**Detailed Site Plan**  
**Alternative Compliance**  
**Giac Son Buddhist Temple**

**DSP-20002**  
**AC-22009**

SUBJECT:      Detailed Site Plan DSP-20002  
                 Type 2 Tree Conservation Plan TCP2-018-2023  
                 Alternative Compliance AC-22009  
                 Giac Son Buddhist Temple

**Figure 2: Institutional Building-Mounted Signage**

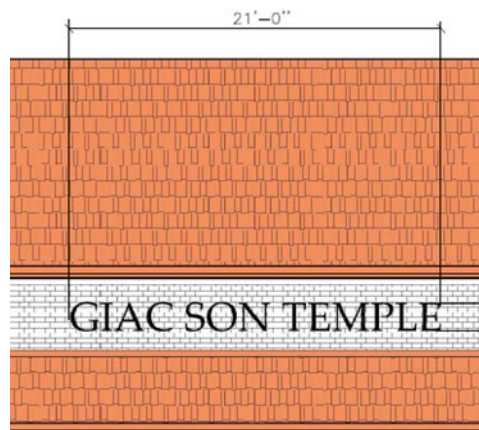
- j. Revise the architectural elevations on Sheet 7 to clearly label the material of the proposed attached signage.
- k. Provide a colored rendering of the freestanding signage proposed on Sheet 10.
